PCN# 20251215001.1
Qualification of TI Clark as an additional Assembly site for select devices
Change Notification / Sample Request

PCN Number:	20251215001.1	**PCN Date:**	December 15, 2025
Title:	Qualification of TI Clark as an additional Assembly site for devices		
Customer Contact:	Change Management Team	**Dept:**	Quality Services
Proposed 1st Ship Date:	March 15, 2026	**Sample requests accepted until:**	February 13, 2026*

Sample product shipping label (not actual product label):

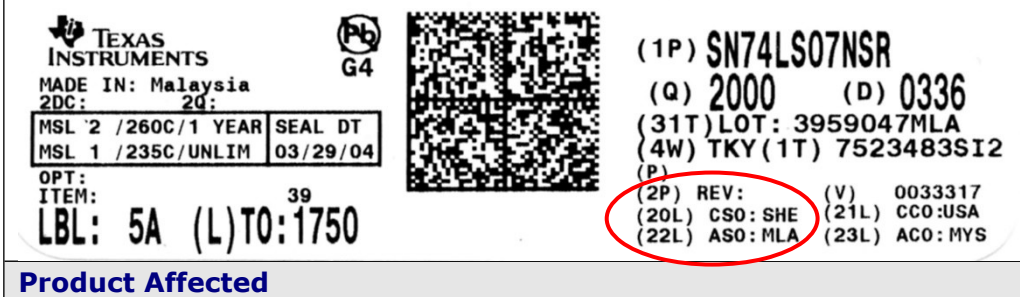
Changes to product identification resulting from this PCN:

Assembly Site Information:

Assembly Site	Assembly Site Origin Code (22L)	Assembly Site Country Code (23L)	Assembly Site City
CDAT	CDA	CHN	Chengdu
Clark	**QAB**	**PHL**	**Angeles City, Pampanga**
